**SKY MOUNTAIN**

**8722 W SH 71**

**SP-2021-0079C**

# VARIANCE REQUEST

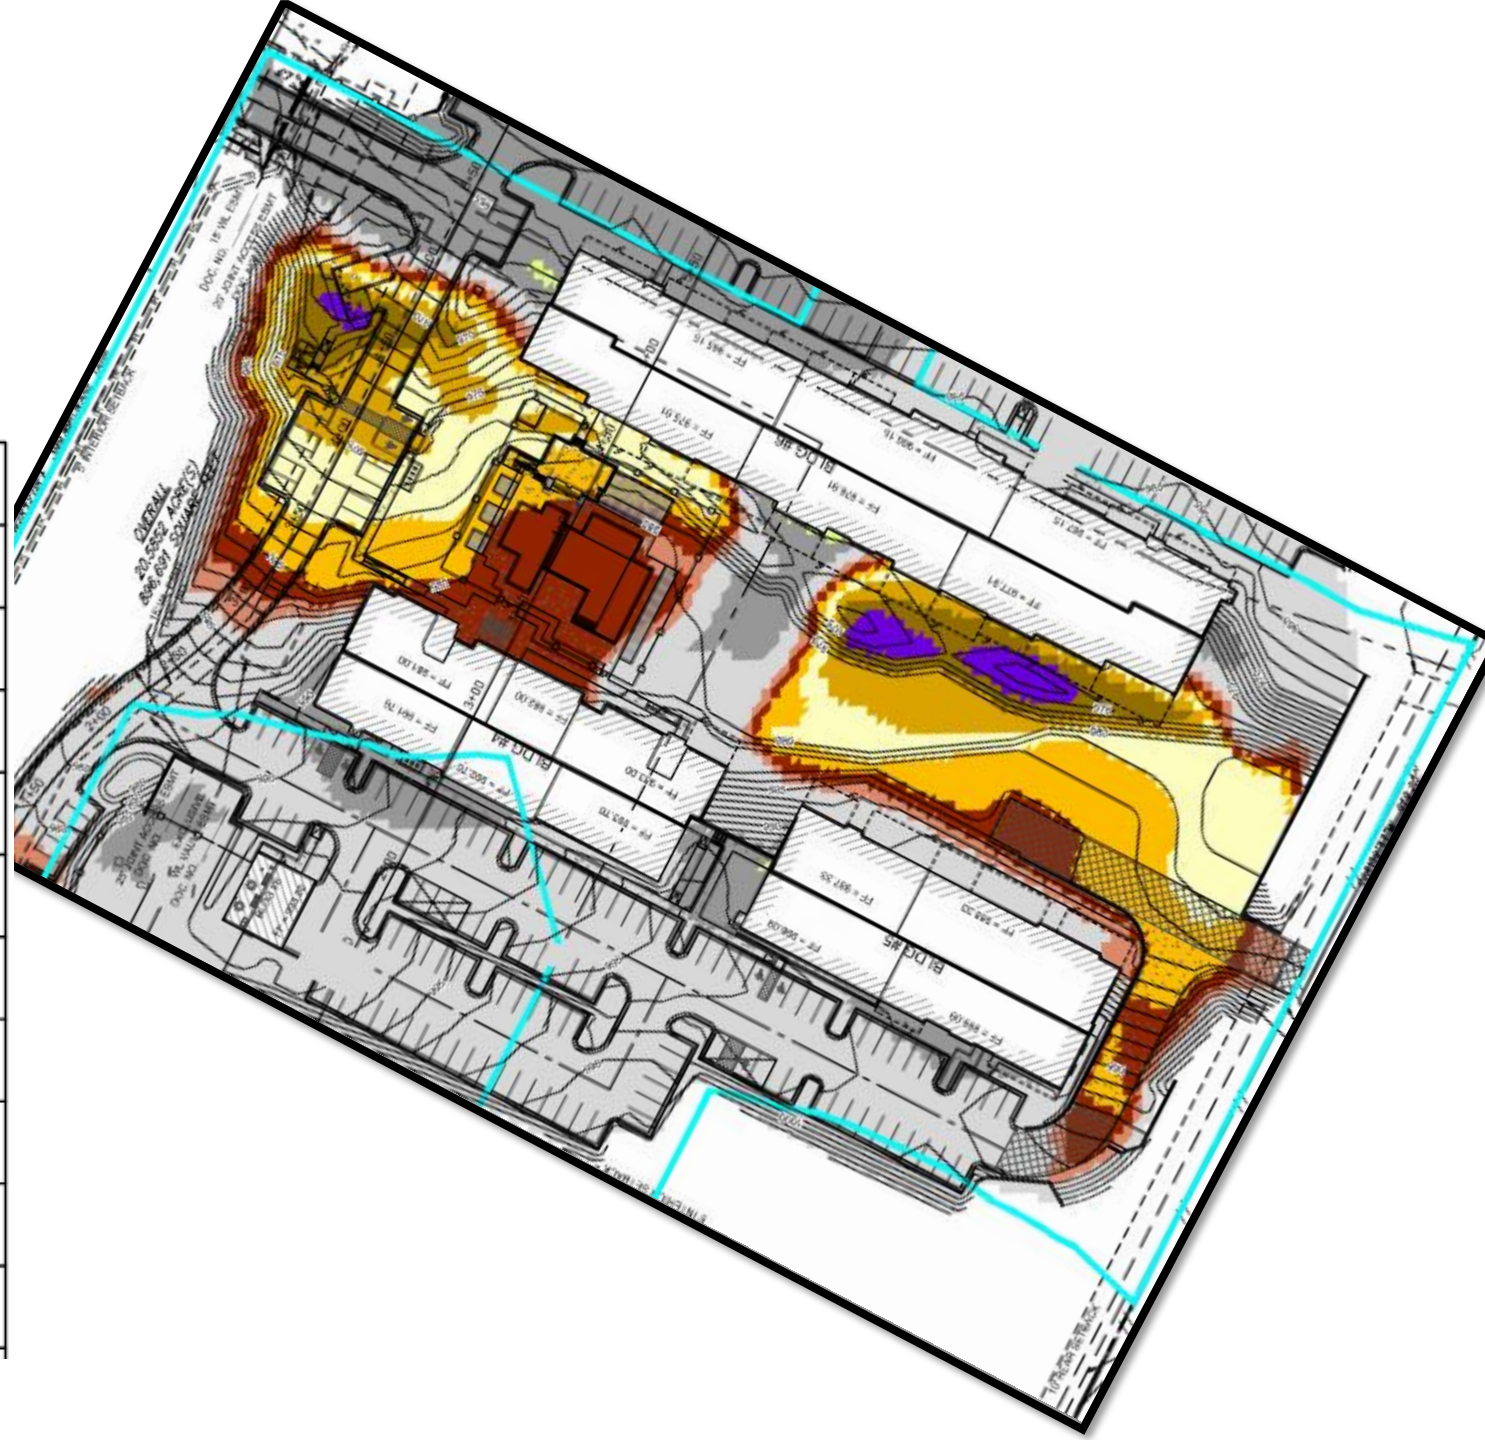
§ 25-8-341 - CUT REQUIREMENTS. (A)  
Cuts on a tract of land may not exceed  
four feet of depth.

1. The variance request is to allow cut  
over 4 feet to 16 feet.

Removal of the fill and development of the site will reduce the potential for future erosion on these steep, artificially constructed slopes.

Staff recommends the variance, with the following conditions.

1. All grading over 8 feet will be contained with terracing or engineered walls.
2. Around the perimeter of the limits of construction, and in areas where more than 3' of vertical rise is proposed, 3:1 slopes will have erosion control matting applied immediately after final grade is achieved.
3. Disturbance in the stormwater irrigation fields will be minimized by restricting the LOC and routing the irrigation lines to preserve existing trees to the greatest extent possible.
